FAIRMAN et al. Application No. 09/555,929

**AMENDMENTS TO THE DRAWINGS:**

## **REMARKS/ARGUMENTS**

Figure 1

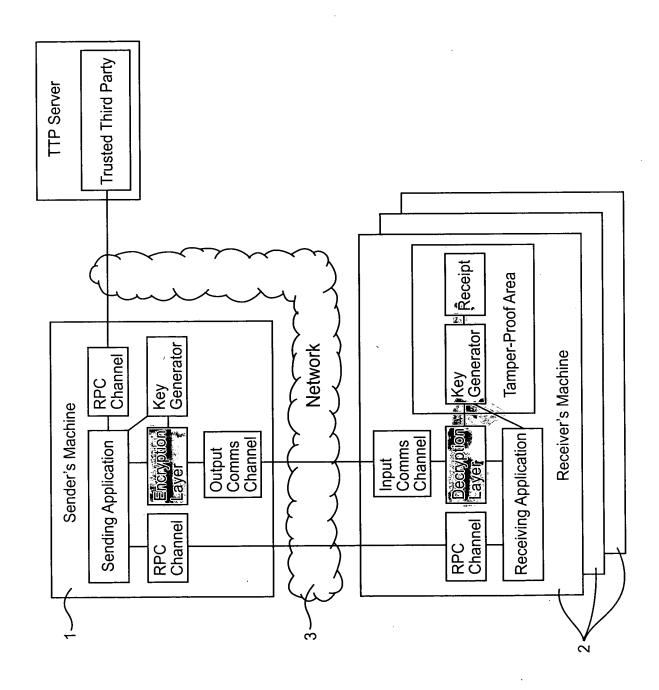
which include Figures 1, 2 and 4, replace the original sheets including these figures. In Figure 1,

previously obscured labels "Encryption Layer" and "Decryption Layer" have been added. In

In Figure 1, labels "Encryption Layer" and "Decryption Layer" has been added. Support for these amendments can be found, for example, on page 6, line 26 to page 7, line 16 of the present specification. (See, e.g., "An Encryption Module in the Data Server 1..." on page 6, lines 28-29 of the present specification).

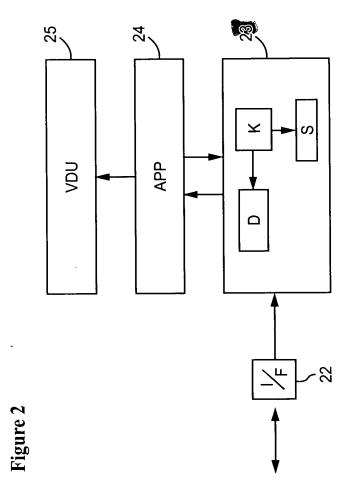
Figure 2, label "23" has been added to replace the label "33"-- consistent with the amendments

Figure 4

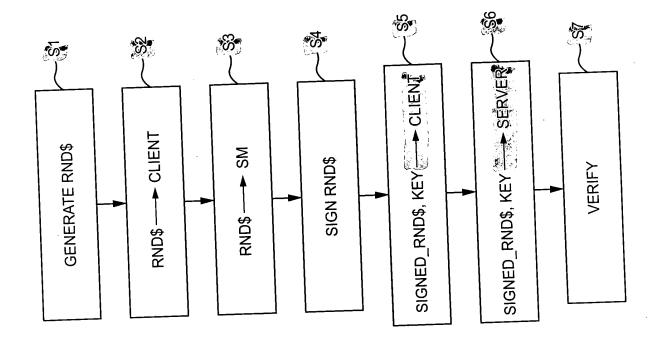
to the drawings filed March 22, 2004. In Figure 4, labels "51-57" have been replaced with labels

"S1-S7", respectively. Clarifying amendments have also been provided to the text within blocks

In Figure 4, labels 51-57 have been changed to S1-S7, respectively. Support for these changes can be found in the paragraph bridging pages 9 and 10 of the present specification.
